SHORT TERM REPORT

UNITED STATES
NUCLEAR REGULATORY COMMISSION
WASHINGTON, D. C. 20555

May 20, 1977

In our meeting on March 23, 1977, at the Jocassee Dam site near the Oconee Nuclear Station, we stated what we consider to be appropriate actions for Duke Power Company to take to allow us to evaluate the potential seismic hazard at the Jocassee Dam.

RECOMMENDED STATION LOCATIONS AT LAKE JOCASSEE

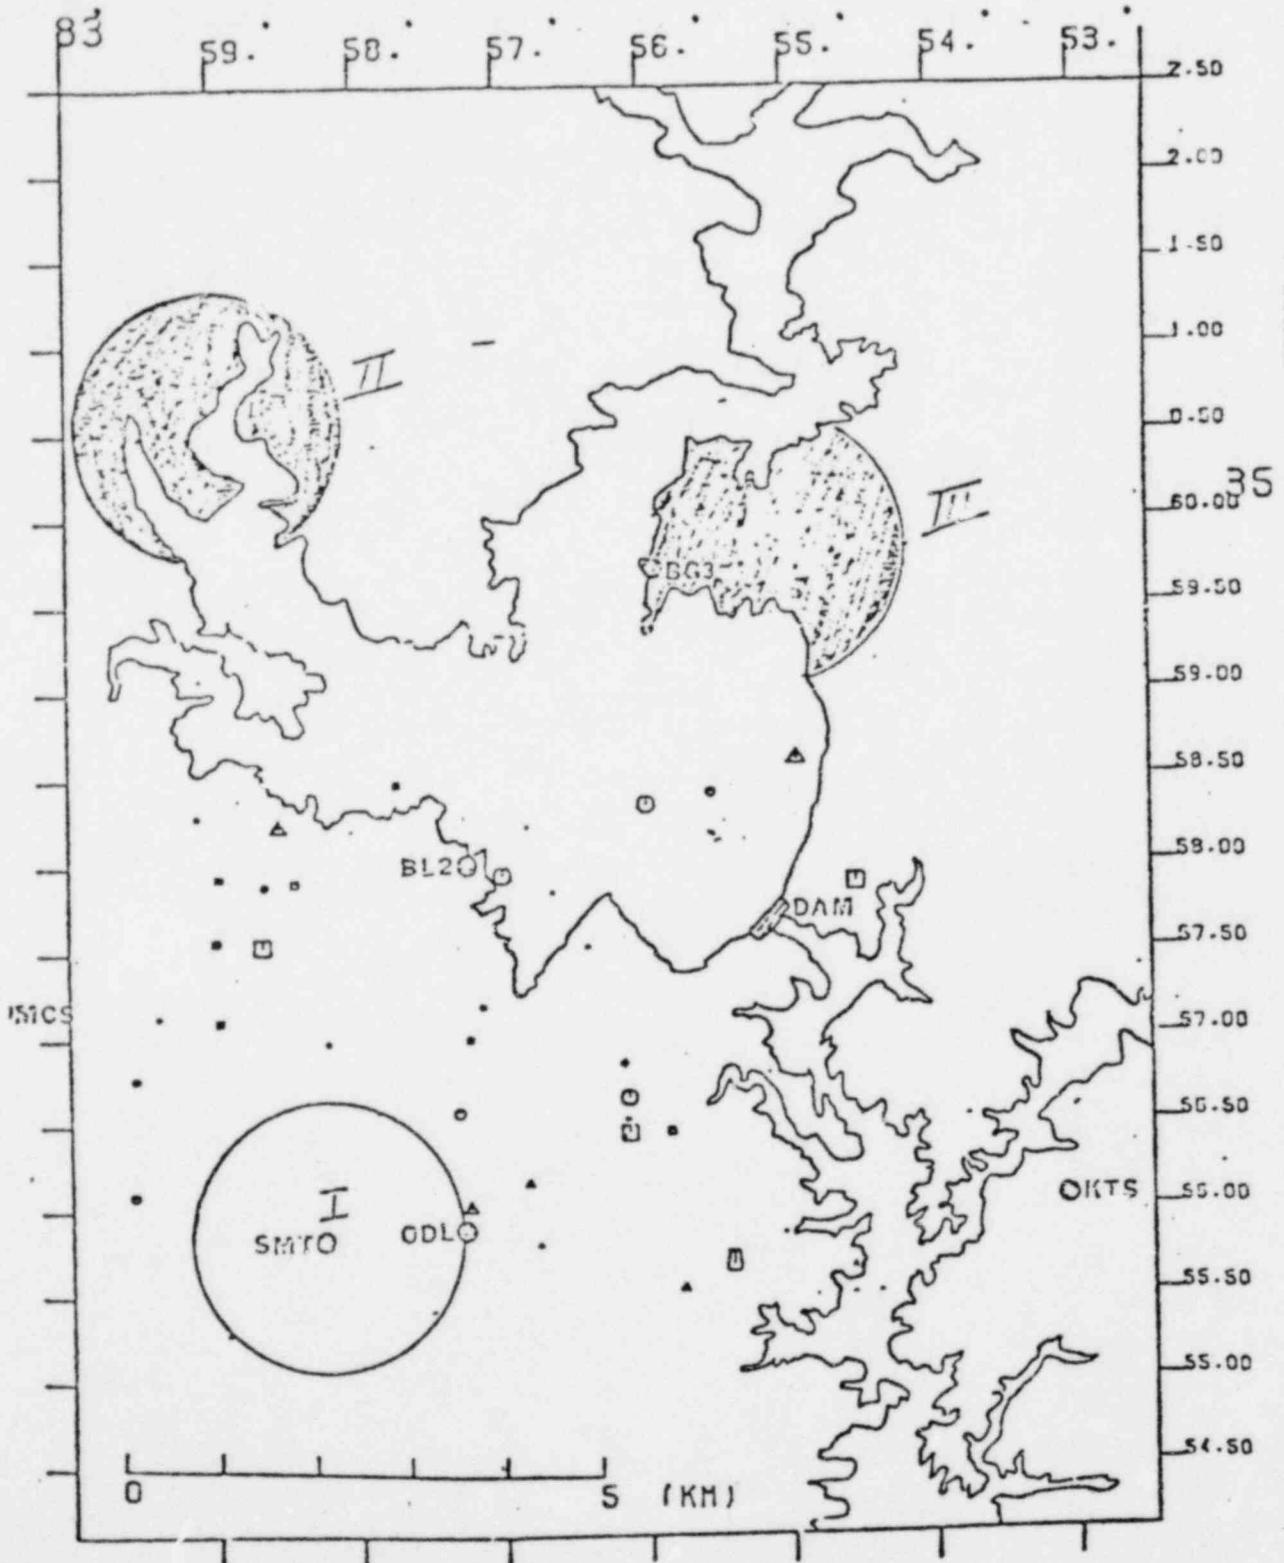
stations in addition to SMT should be installed as soon as possible. Suggested locations for these stations are shown in the attached figure. If possible, arrangements should be made with the USGS and USC to incorporate one or all of the Jocassee stations in the South Carolina network. This would allow recording of these stations on the delevelocorder at USC. If arrangements are made to include the stations in the network, it may be possible to use USGS radio frequencies for radio telemetry.
